Subject: Docket No. 50-329/330
 Midland Plant - Units 1 and 2
 Overview of the Construction
 Completion Program
 Serial No. SWMCP-021

Re: FCR/FCN Review (Electrical)

STONE AND WEBSTER ENGINEERING CORPORATION
NONCONFORMANCE IDENTIFICATION REPORT

E No 105

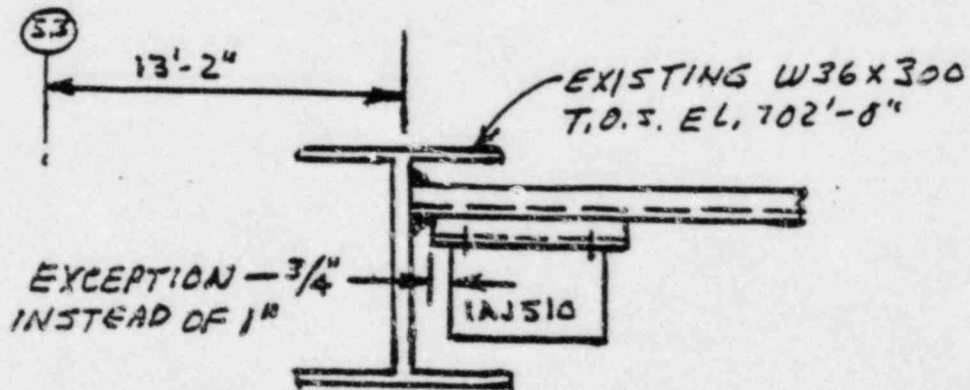
REASON FOR CHANGE
SPACE LIMITATIONS

EXISTING CONDITION
BOX 1AJS10 REQUIRES A SUPPORT

DESCRIPTION OF CHANGE
TYPE 22 JUNCTION BOX SUPPORT WITH
EXCEPTION AS SHOWN

EL. LOOKING NORTH, 2 FEET
NORTH OF K LINE

RETIRED
DOCUMENT REVISION
NOT REQUIRED
Signed *[Signature]* Date 8-21-79

REMARKS
NO DRAWINGS INCORPORATION REQUIRED
